Bulletin No.:	9573L30-01
Corp. Rel. No.:	57-71-09
Date:	April, 1995

Product Service Bulletin

SUBJECT: TORQUE CONVERTER CLUTCH (TCC) CHUGGLE/HUNTING CONDITION

MODELS: 1989-1995 GEO TRACKER, CAMI VITARA, SUZUKI SIDEKICK
WITH HYDRA-MATIC 3L30 AUTOMATIC TRANSMISSION

Figure 1

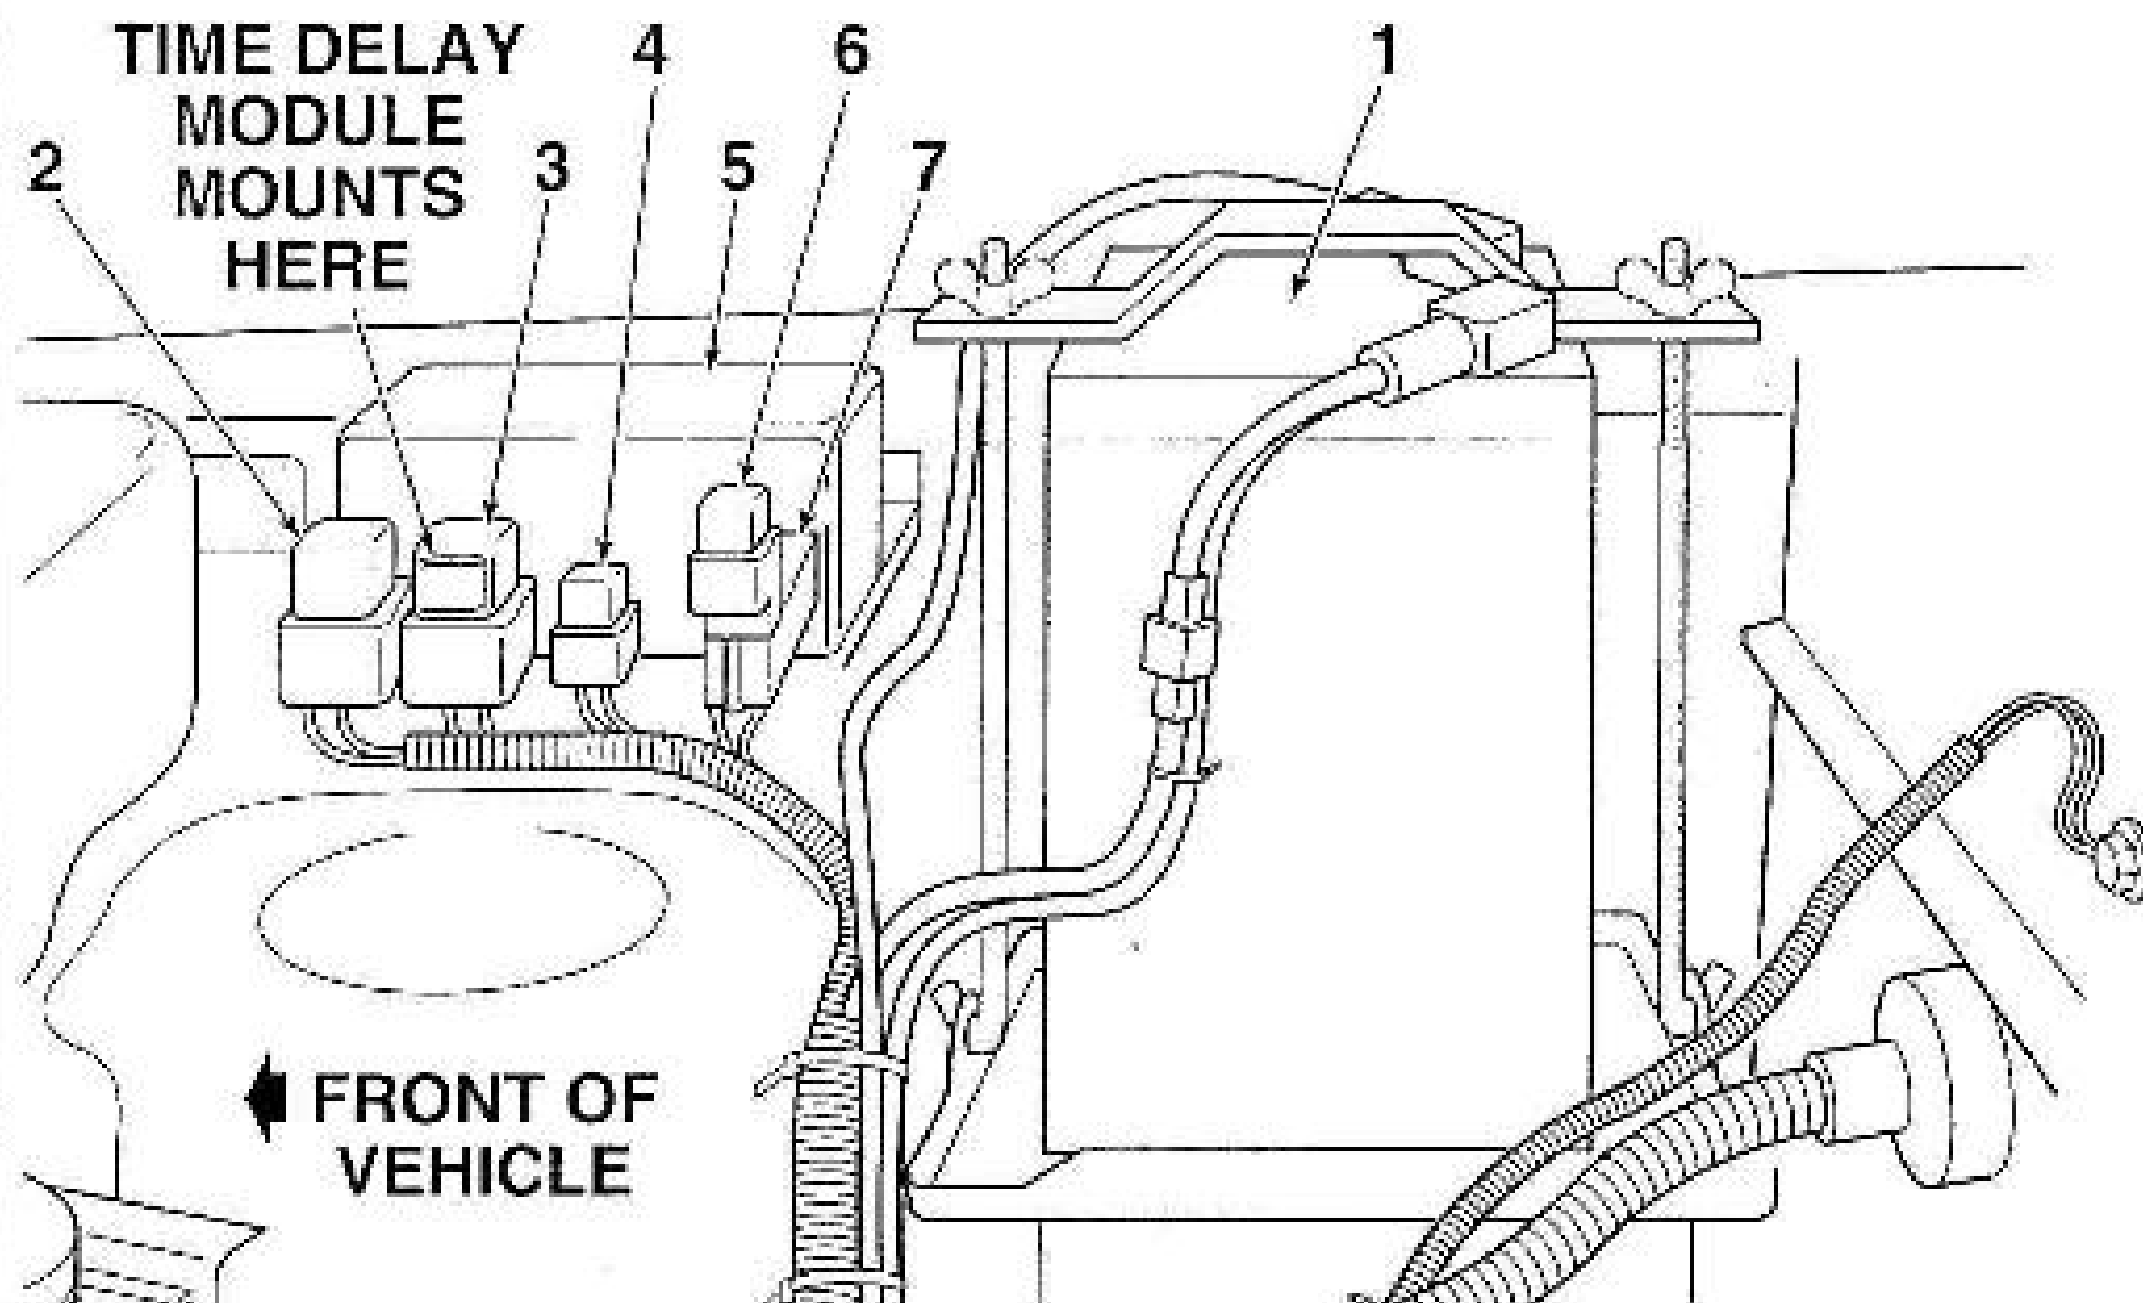
3. Disconnect the white wire from the green connector. Remove the terminal **carefully** with a narrow screwdriver as indicated. (Figure 1)
4. Connect the white wire to the Time Delay Module and wrap with electrical tape. Install the red wire from the Time Delay Module into the open terminal of the green TCC relay connector. (Figure 4)
5. Reconnect the green connector to the TCC relay and install the TCC relay onto the relay center. (Figure 4)
6. Clip the Time Delay Module onto the A/C fan relay. (Figure 3)

Figure 1

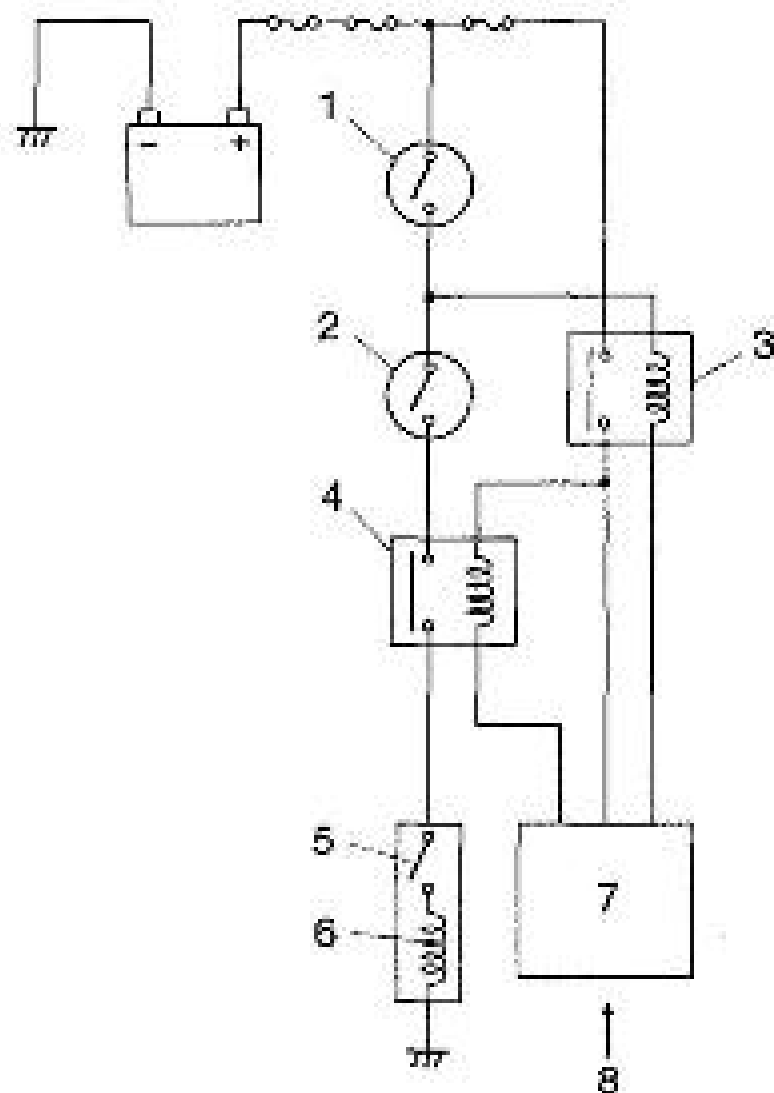
CONDITION: Change in diagnosis of TCC Relay Control System.

CAUSE: Modification in the ECM.

This bulletin is to inform you of a modification in the ECM which is effective in 1995 model year vehicles matching or exceeding the VIN numbers listed below. The Torque Converter Clutch (TCC) Relay Control System in 1995 and later 2-door Sidekick Automatic Transmissions has been modified to operate through ECM control, replacing the Pressure Switch in the valve body. Because of this modification, the ECM and the diagnostic procedures related to the TCC Relay Control System have been changed. If the vehicle matches or exceeds the starting VIN numbers listed below, please use the diagnostic procedures as listed in this bulletin.

CORRECTION: When diagnosing the TCC Relay Control System, use the testing procedures as listed in this bulletin.

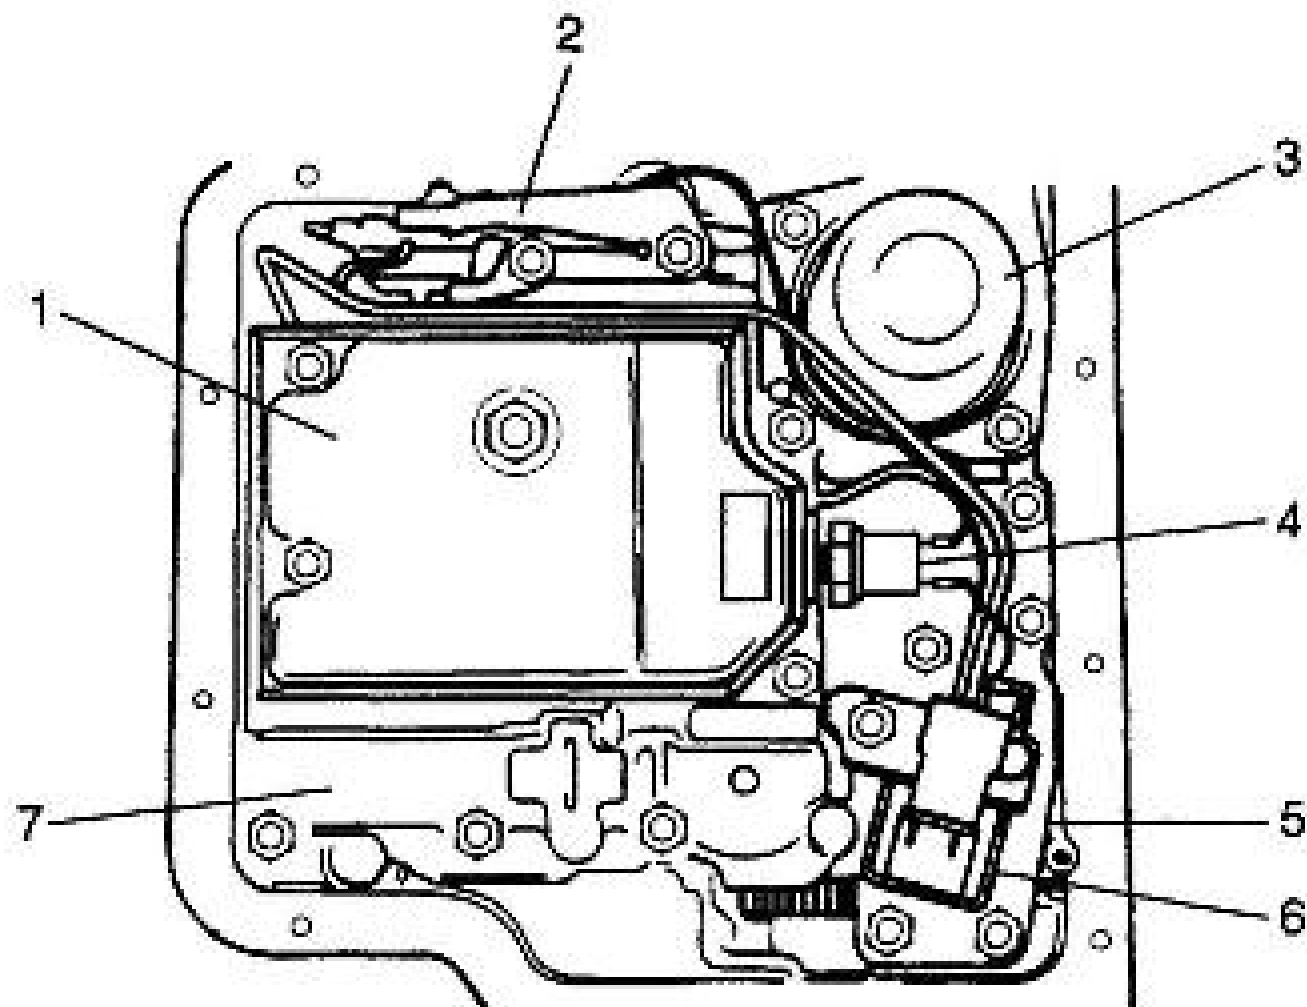
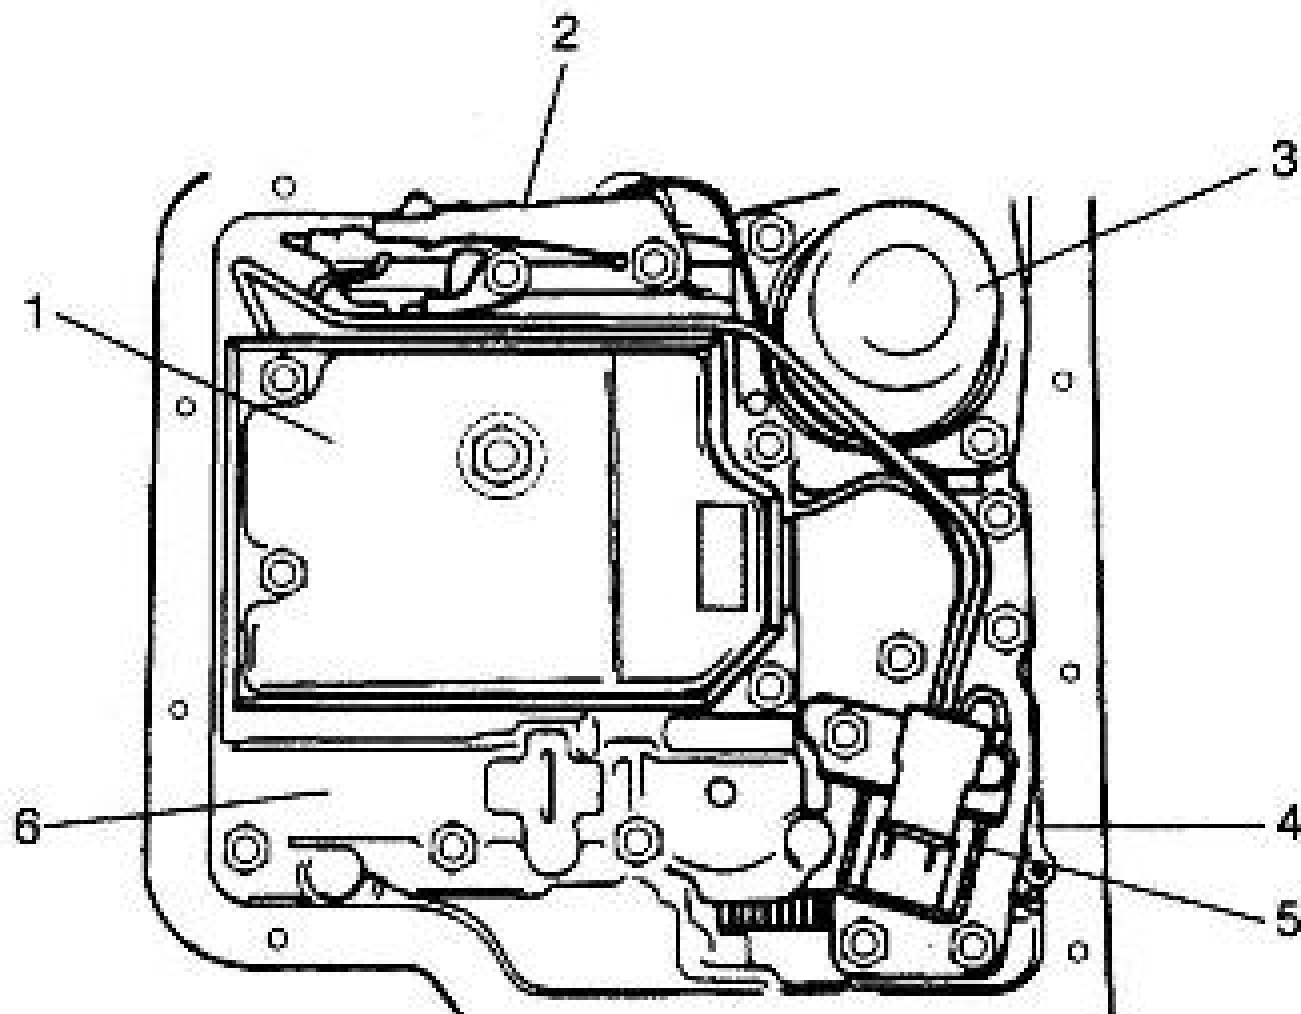
CONDITION: Change in Automatic Transmission; elimination of A/T oil pressure switch.

This bulletin is to inform you of the elimination of the Torque Converter Clutch (TCC) Oil Pressure Switch which has been carried out since May 1995 production for Canadian models and August 1995 production for Japan models. Due to this modification, the diagnostic procedures for the TCC system in the service manual have been changed. Please refer to Technical Service Bulletin #TS 3-25 to diagnose this system.

CORRECTION: When diagnosing the TCC system, please use the information as listed in this bulletin.

Figure 1

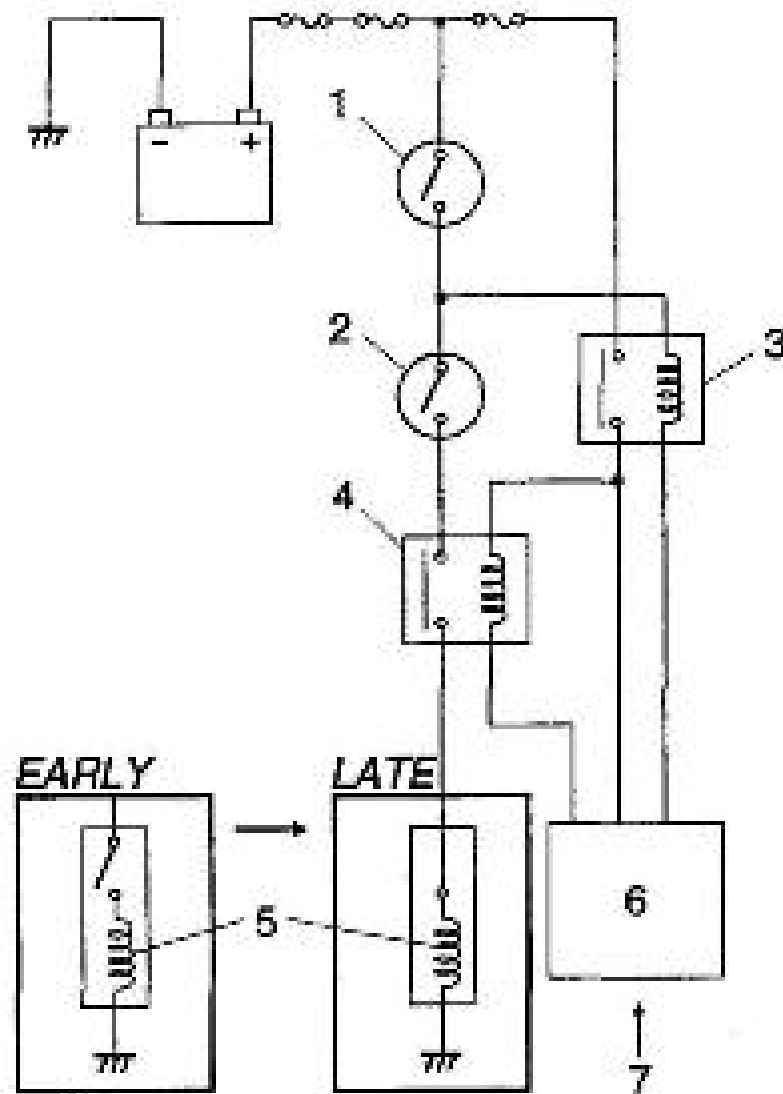
For diagnostic procedure, please refer to Technical Service Bulletin #TS 3-25. Also note that the continuity check between ① pin of TCC relay coupler and ground is not needed due to the elimination of the A/T oil pressure switch.
